<b>Topic</b>	Software Update   Window Short Drop Deletion   Continental GT/GTC   26MY (SC25 /31)
<b>Market area</b>	Bentley: worldwide (2WBE),China 796 VW Import Comp. Ltd (Vico), Beijing (6796)
<b>Brand</b>	Bentley
<b>Transaction No.</b>	2078277/41
<b>Campaign number</b>	ED59
<b>Note</b>	
<b>Type</b>	
<b>US code</b>

Software Update | Window Short Drop Deletion | Continental GT/GTC | 26MY  
(SC25/31)

Release date: May 18,  
2026

Figure 1

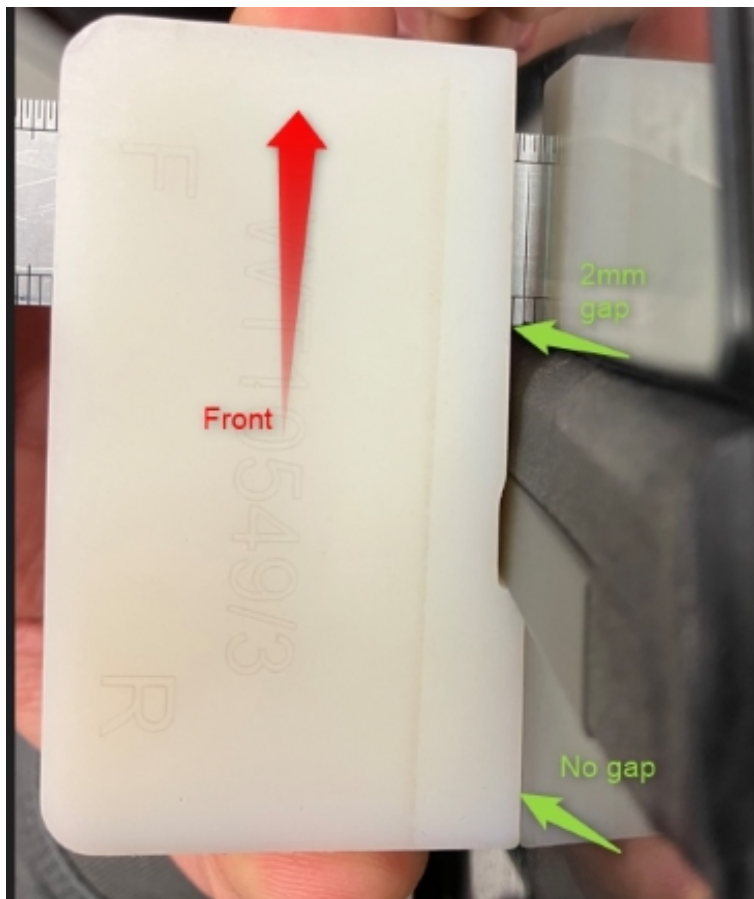
When the window is parallel take the 2mm step from the tool and minus the 2mm gap between front window and tool = -0mm (as shown in figure 1)

Figure 3

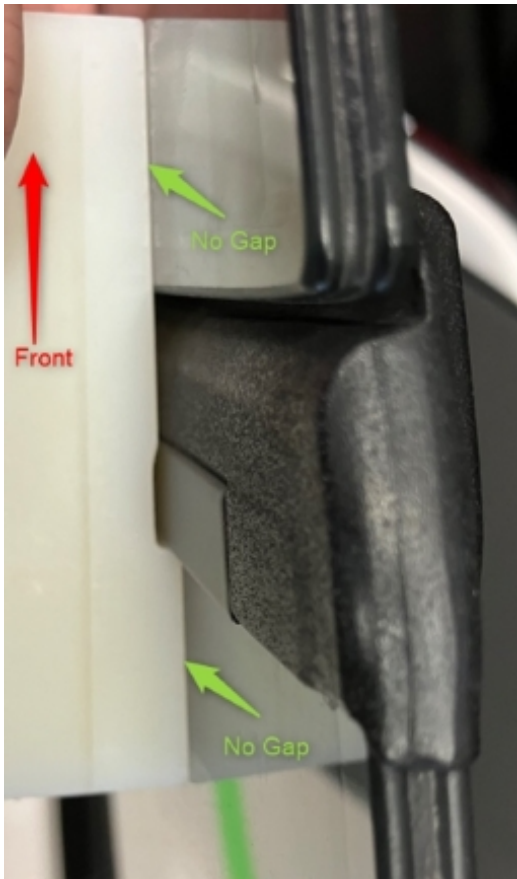
When the rear window is inboard and there is a 2mm step from the tool, when there is no gap between either window and tool (figure 3), the recorded measurement should be -2mm (figure 4)

Figure 5

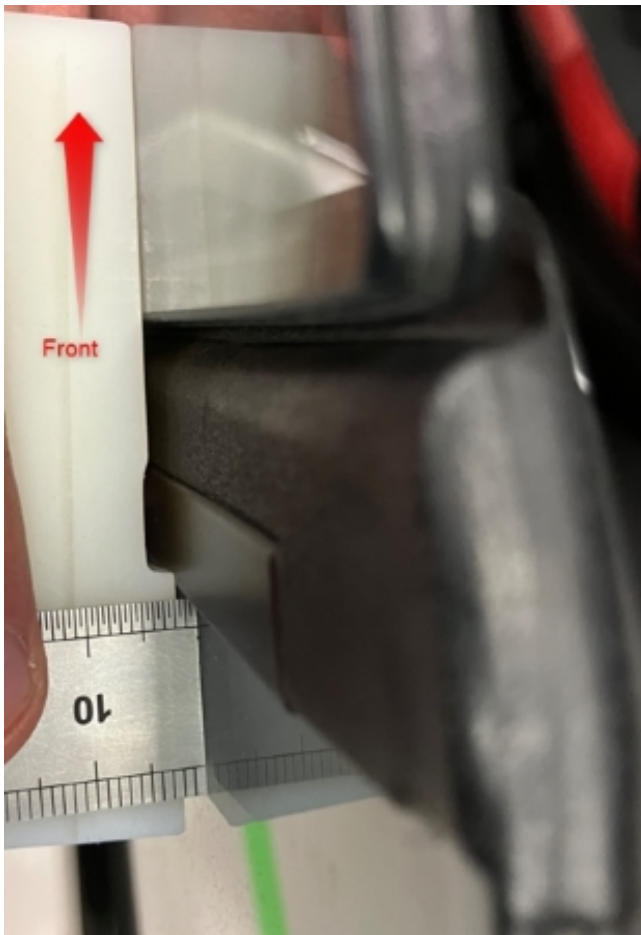
When the rear window is inboard and there is a 2mm step from the tool as well as an additional 1.5mm gap to the window (figure 5), the recorded measurement should be -3.5mm (figure 6).

Figure 7

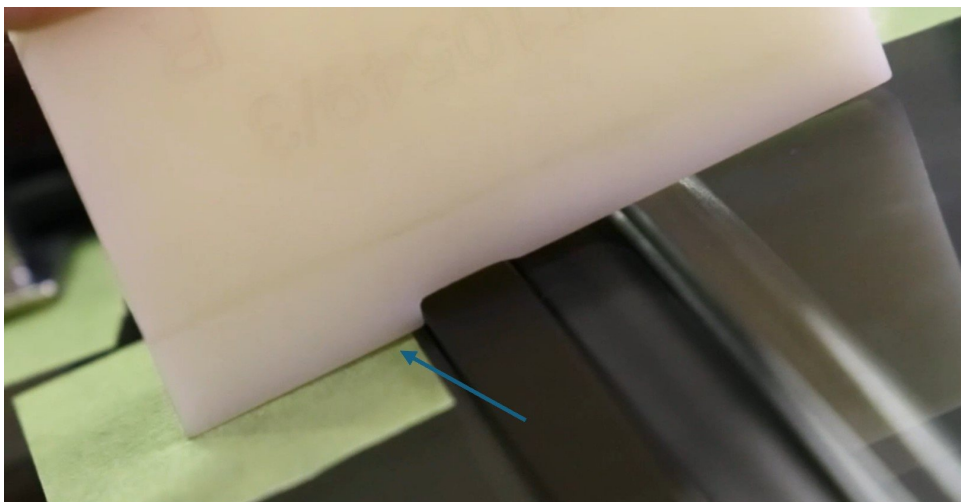
If the tool (WT10549/3) does not sit flush against the rear window then this shows rear window is more than 2mm inboard (more than -2mm), check this by holding the tool on the front window and measuring gap between the rear glass and the tool (as shown in figure 7)

Figure 10

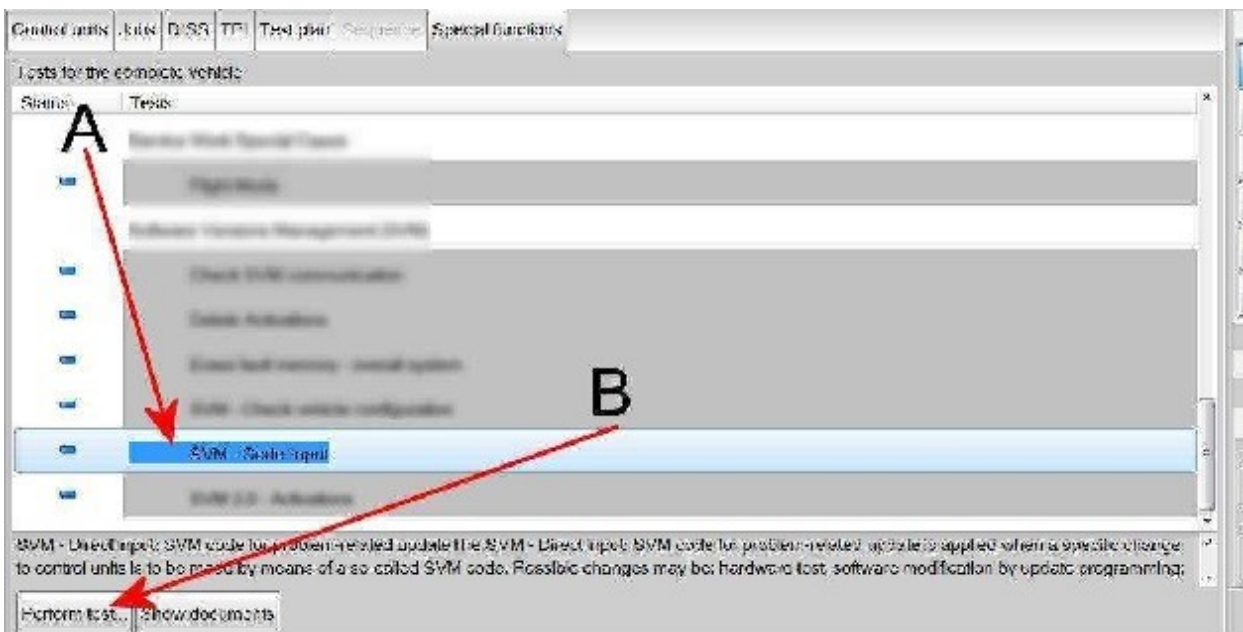
2) Referring to Figure 10 - Within the Special functions tab - Select SVM - Code Input (Point A)

• Select Perform test (Point B)

Figure 11

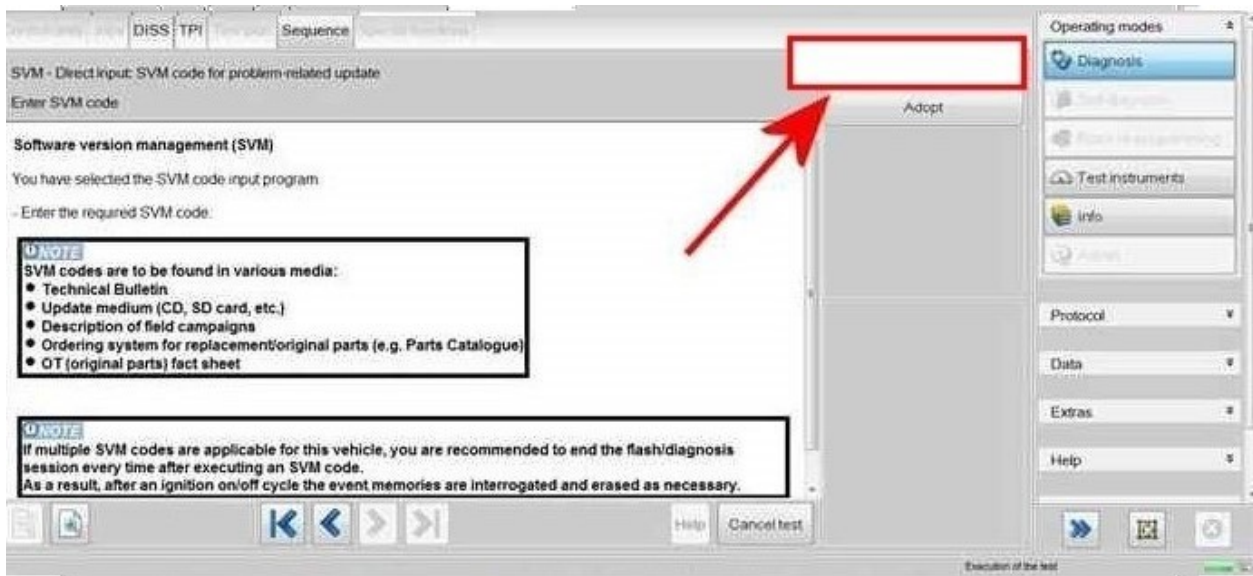
3) Referring to Figure 11 - Enter the SVM code **372WDD02**
